Access Compliance Report

Public Rights-of-Way

(Curb Ramps)

Intersection ID: 30613	Main Street: GOLF_LINKS_DR	Cross Street: PROVIDENCE_RD	Location: SE
ADA ID: E9177FD9BCC6	Ramp Type: Perp	Initial Pass/Fail: Fail	Overall Compliance: No
Severity Score: 8.75			
Codes/Mitigation Info/Possible Solution		Field Measurements/Component Compliance

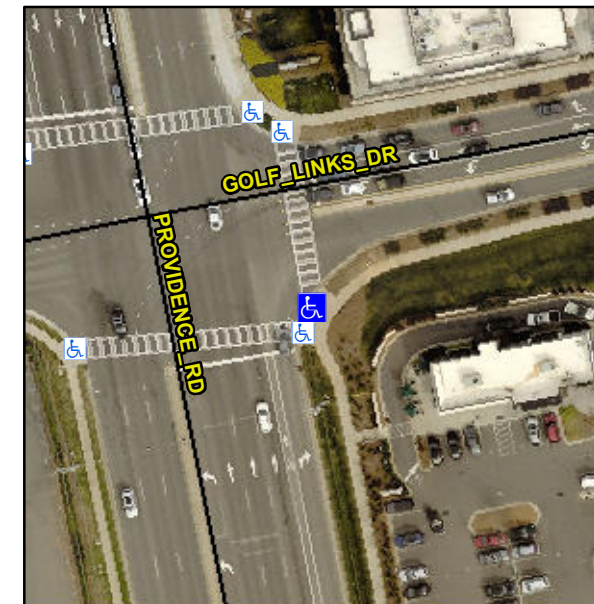
Not Found, R304.5.1

Compliance	Description	Data	Compliance	Description	Data
N/A	Ramp Length (in)	96.0	Yes	Ramp Slope (%)	7.5
No	Ramp Width (in)	46.5	Yes	Ramp XSlope (%)	0.3
N/A	Flare Type LT	N/A	N/A	Flare Type RT	N/A
N/A	Flare Slope LT (%)	N/A	N/A	Flare Slope RT (%)	N/A
N/A	Flare Traversable LT?	N/A	N/A	Flare Traversable RT?	N/A
N/A	Landing Length (in)	N/A	N/A	DWS Provided?	N/A
N/A	Landing Width (in)	N/A	N/A	DWS Contrast?	N/A
N/A	Landing Slope (%)	N/A	N/A	DWS Length (in)	N/A
N/A	Landing X Slope (%)	N/A	N/A	DWS Full Width?	N/A
N/A	Landing Curb? (Y/N)	N/A	N/A	DWS Offset (in)	N/A
N/A	Shared Landing?	N/A			
N/A	Gutter Ponding?	N/A	N/A	Gutter Slope (%)	N/A
N/A	Gutter Lip Ht (in)	N/A	N/A	Gutter X Slope (%)	N/A
N/A	Painted X Walk1?	No	N/A	Painted X Walk2?	N/A
	X Walk 1 Direction	To N		X Walk 2 Direction	N/A
N/A	X Walk 1 Width (in)	N/A	N/A	X Walk 2 Width (in)	N/A
	X Walk 1 Slope (%)	5.3		X Walk 2 Slope (%)	N/A
	X Walk 1 X Slope (%)	2.4		X Walk 2 X Slope (%)	N/A

Remove & Replace Entire Ramp.
